SERVICE	B0503004
BULLETIN	2005-04

Subject: Mulch kit for IZT walk behind mower (539104730)

Models Affected: WH3615IZT- 968999237

Baffle number #539110083

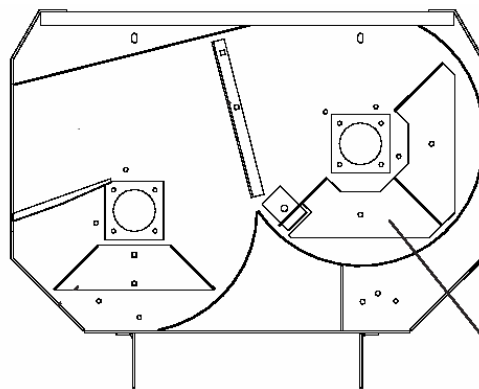
Interference between the left baffle and the bolt on the deck idler has been discovered, when mounting a mulch kit (539104730) on the 36 inch IZT walk behind. A modified baffle, part (539110083) can be ordered to allow proper installation for this series of 36 inch walk behind.

A new mulch kit # 539110084 has been introduced and is adaptable to gear walk 36" as well as 36" IZT units.
